Prairie Island Independent Spent Fuel Storage Installation
Docket 72-10
Renewed Materials License No. SNM-2506

Response to Request for Additional Information: License Amendment Request to Expand the Storage Capacity of the Independent Spent Fuel Storage Installation (ISFSI) (EPID No. L-2019-LLA-0169)

Response to Request for Additional Information

License Amendment Request to Expand the Storage Capacity of the Independent Spent Fuel Storage Installation (ISFSI)

**Figure 6.1: Overview of the Computational Domain
(Cross-Section in Figure 6.2 is Highlighted)**

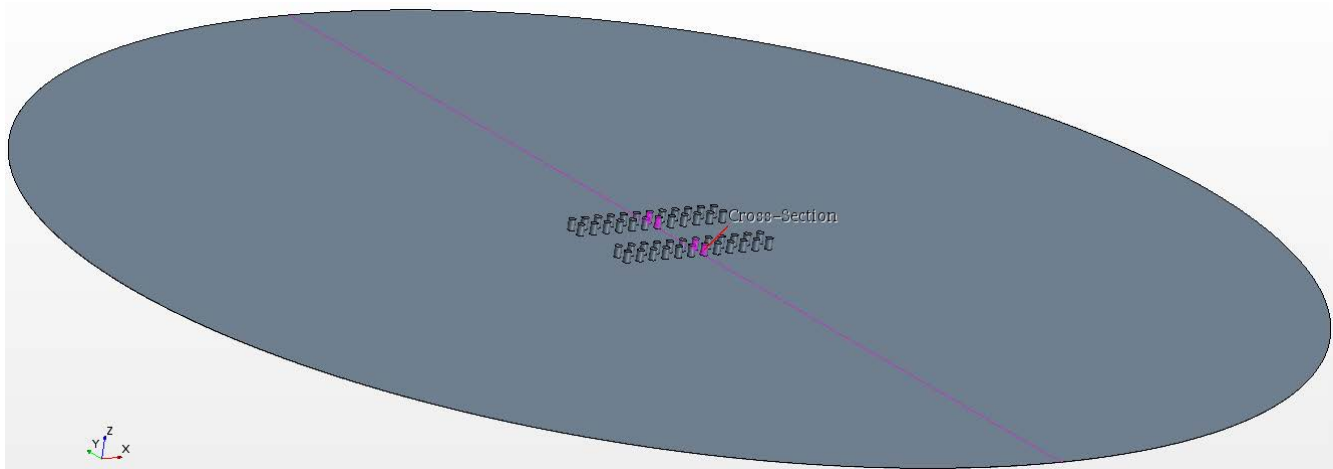
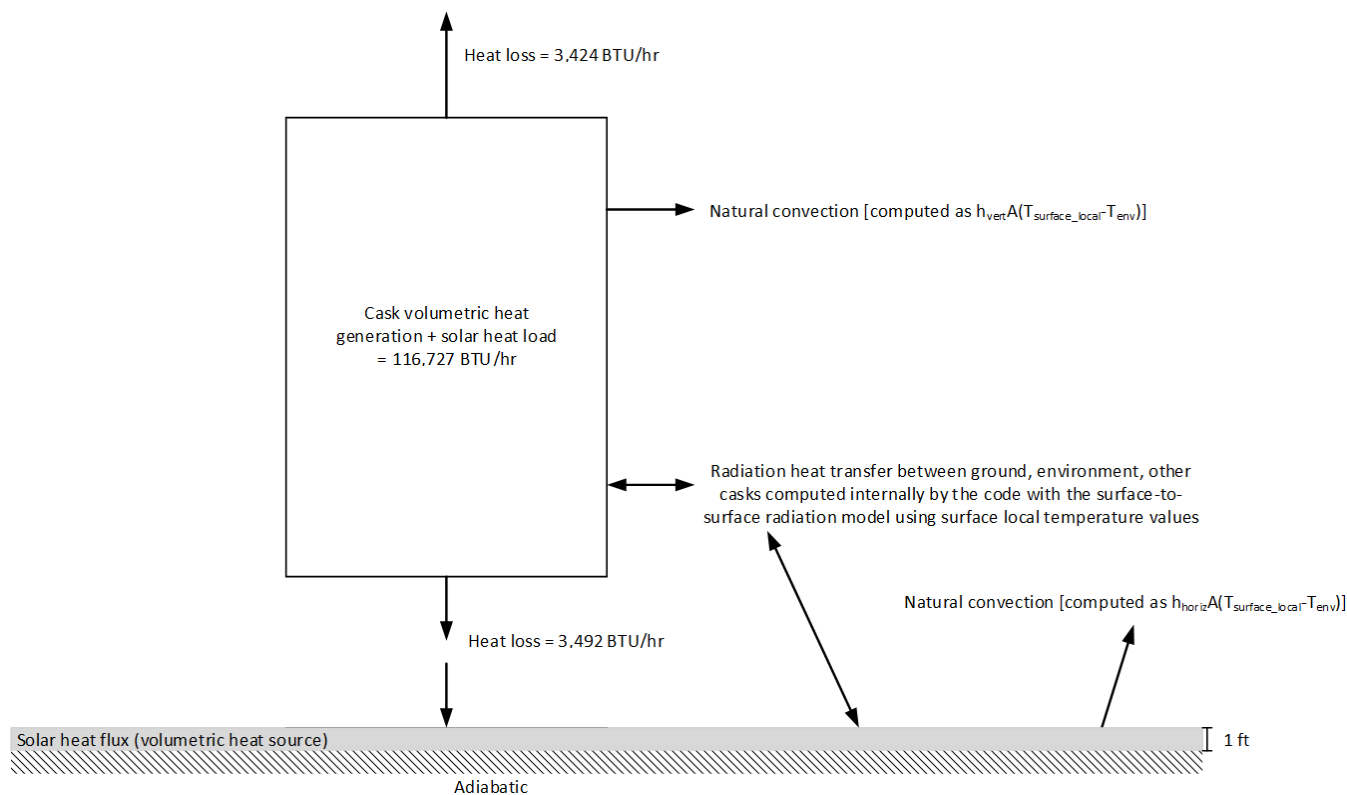
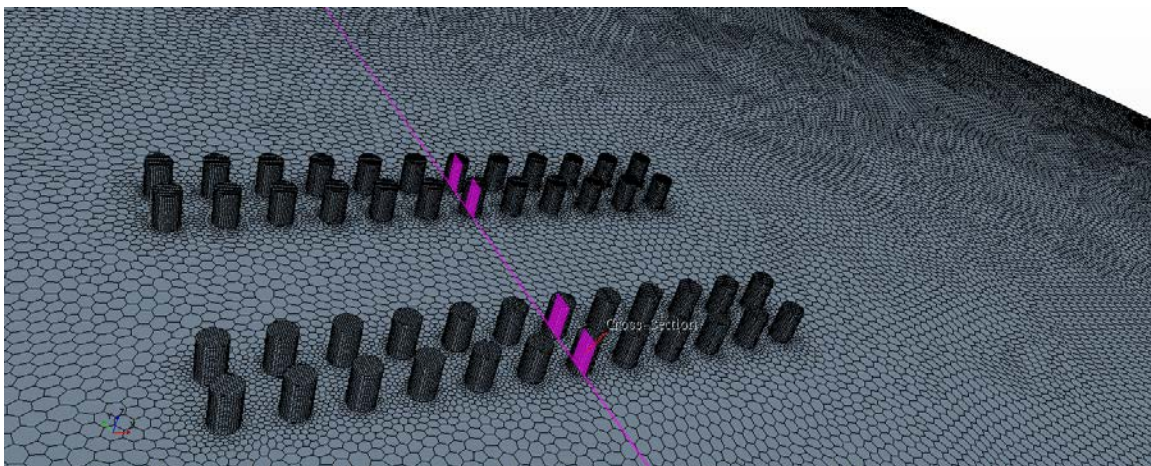
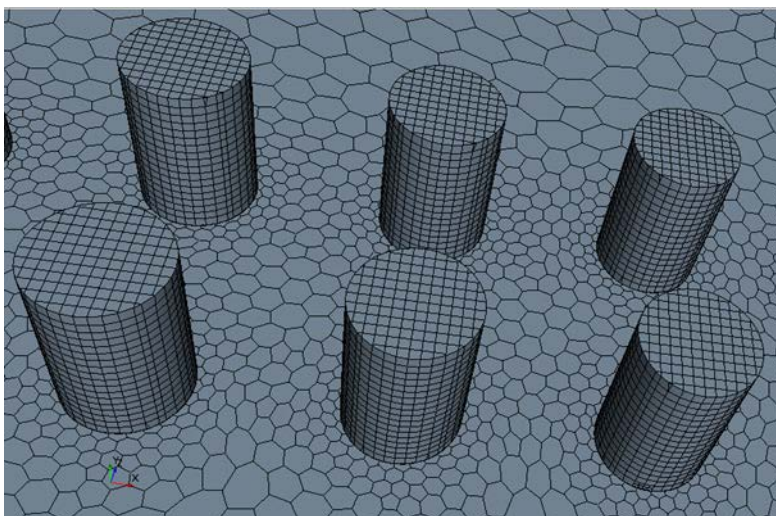
Provide a detailed discussion of the method of evaluation (MOE) used to demonstrate that the thermal performance of the TN40HT casks currently in place on the existing ISFSI pads are not adversely affected by the deployment of the proposed ISFSI pad expansion.

1. Comparison tables of input parameters used for the existing finite element analysis of the ISFSI and those used in the CFD analysis for the alternate MOE.
2. The approach taken by the applicant was to use a previously approved modeling approach to validate the alternate modeling approach. Since a method of evaluation includes inputs and other modeling choices, it is appropriate to provide a clear representation of similarities between the existing analyses and the proposed MOE, for each of the elements relied upon to make the proposed MOE complete.
3. A thorough discussion of the following:
 - a. mesh generation, including appropriate plots, and applicable sensitivity studies.
 - b. treatment of boundary conditions.
 - c. the final thermal radiation model used.
 - d. how the heat transfer out of the top of the casks is treated.

Figure 6.1 shows the entire geometry of the model, while Figure 6.2 shows a cross-section through the geometry. As seen, the model includes homogenous solid cylinders (internal details of the casks are not included), which represent the casks, and a thin (1 ft) homogenous solid slab, which represents the pad/ground. The model includes external surface-to-surface

Figures 6.4 and 6.5 show an overview and cross-section of the mesh used for the analysis, respectively. Figure 6.6 shows a close-up view of the surface mesh since it is relevant to the analysis performed in this calculation. The model is discretized in a total of approximately 300,000 cells. Each cask's side surface accounts for approximately 700 trimmer faces 0.7 ft wide; the pad/ground upper surface accounts for approximately 95,000 polyhedral faces between 0.7 ft (in proximity of each cask) and 5 ft wide (farther from the casks). Mesh independence studies were performed to ensure that the results were mesh independent.
